UNITED STATES PATENT AND TRADEMARK OFFICE

APPLICATION NO.	FILING DATE	FIRST NAMED INVENTOR	ATTORNEY DOCKET NO.	CONFIRMATION NO.
10/757,379	01/13/2004	Harold D. Hutchinson	4056	3616

Office Action Summary

DETAILED ACTION

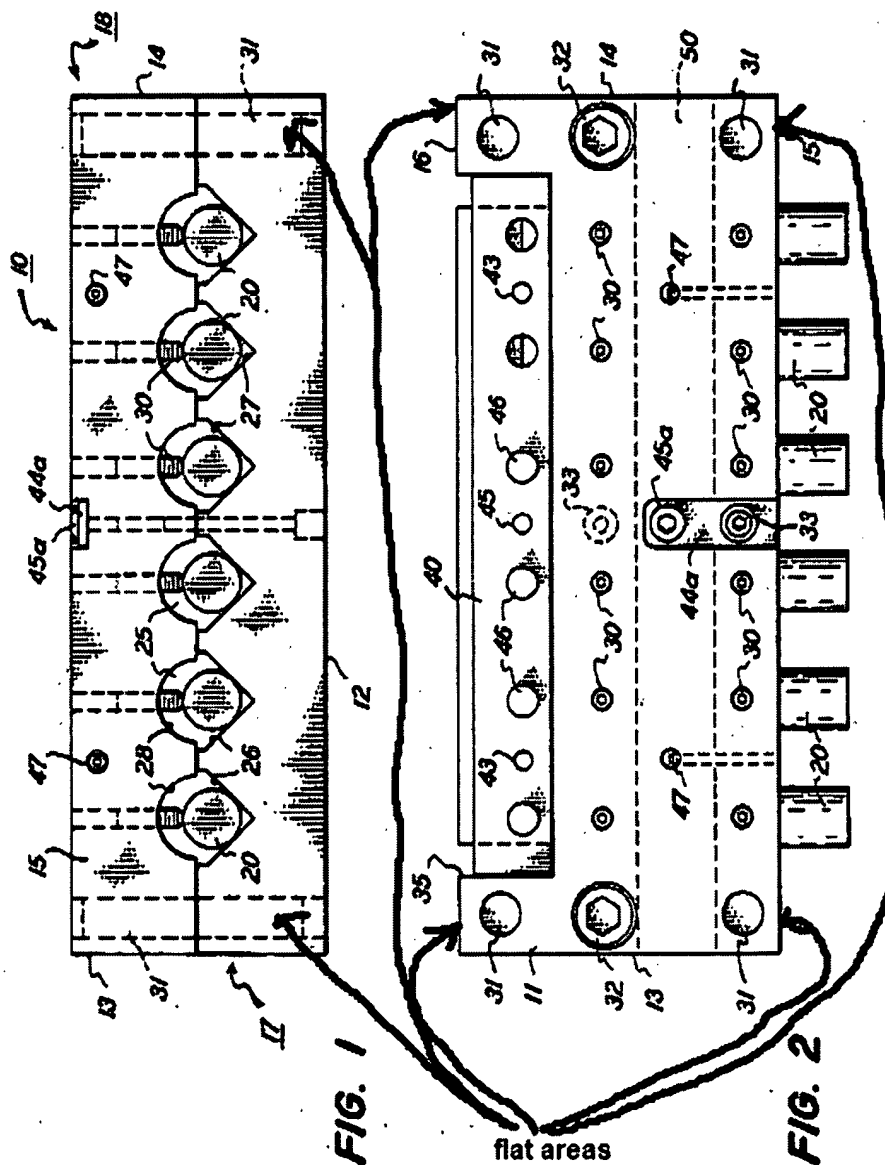
- b. Regarding claim 2, Jaskolski discloses the same invention as the applicant, including first and second crimping blocks being rectangular (See Figs. 1, 2, and 5).
- c. Regarding claim 3, Jaskolski discloses the same invention as the applicant, including the first and second crimping blocks being approximately equal in size (See Figs. 1, 2, and 5).
- d. Regarding claim 5, Jaskolski discloses the same invention as the applicant, including the height of each of said plurality of ribs being selected to nearly fully engage a respective trough in the second crimping block. Each set screw 30 can be adjusted so as to be closer or farther away from a corresponding trough.
- e. Regarding claim 9, Jaskolski discloses the same invention as the applicant. See the discussion in part a above regarding both bores being

threaded. Therefore the bolts (screws 32) would be retained when the second crimping block is separated from the first crimping block.

f. Regarding claim 14, Jaskolski discloses the same invention as the applicant, including a second crimping block having flat areas on at least one end for gripping the crimping device, (see image below).

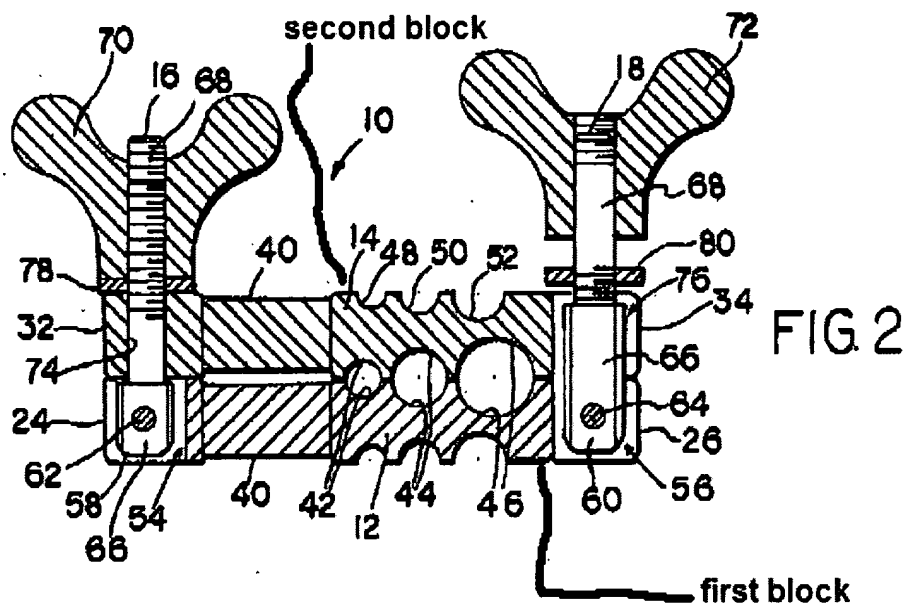
Wilson teaches providing a second block (see figure below) of a device with troughs on two opposite faces of the block, the troughs being of varying sizes, so as to double the total number of troughs (relative to the number of troughs on only one of the faces, i.e. 8 instead of 4) and thereby allow the device to be capable of engaging twice as many different sizes of tubes (one face can engage a tube having one of four different sizes, the other face can engage a tube having one of four sizes different from the first four sizes, whereby the total number of different sizes is eight) (see figure below; also see col. 1, lns. 55-65 of Wilson)
